TRAVEL REPORT

Subject: Travel to Tom Green County Water Control and Improvement District #1 near San Angelo,
Texas

Review of Water Measurement and Water Distribution Infrastructure and Operations

**Tom Green County Water Control and Improvement District #1
San Angelo, Texas**

Figure 7. — Mounting bracket for a Sparling meter at a typical turnout.

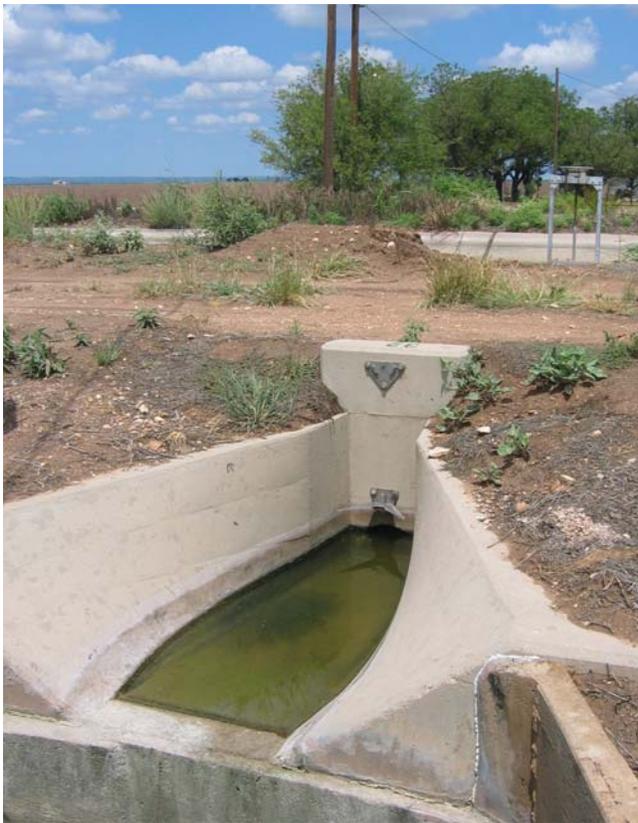
The district seems comfortable operating either type of turnout. Originally, the project was equipped with a dedicated Sparling meter at each turnout, but the expense of maintaining so many meters was excessive. Today the district's two ditchriders each use one meter with a backup kept available. Newly reconditioned meters with stiffer bearings are reportedly unable to

measure flows less than 1 ft³/s. Yantis Green reported many customer service difficulties dealing with the Sparling Instruments company, including meters that were delayed excessively and then shipped back to the district still in non-working condition. The district should consider utilizing a third-party provider for maintenance and recalibration of meters. Two of many possibilities are:

- The acoustic water level sensor at the Parshall flume should be located at the same cross section as the stilling well inlet.
- Consider utilizing a third-party provider for maintenance and recalibration of Sparling flow meters. Two possibilities are:
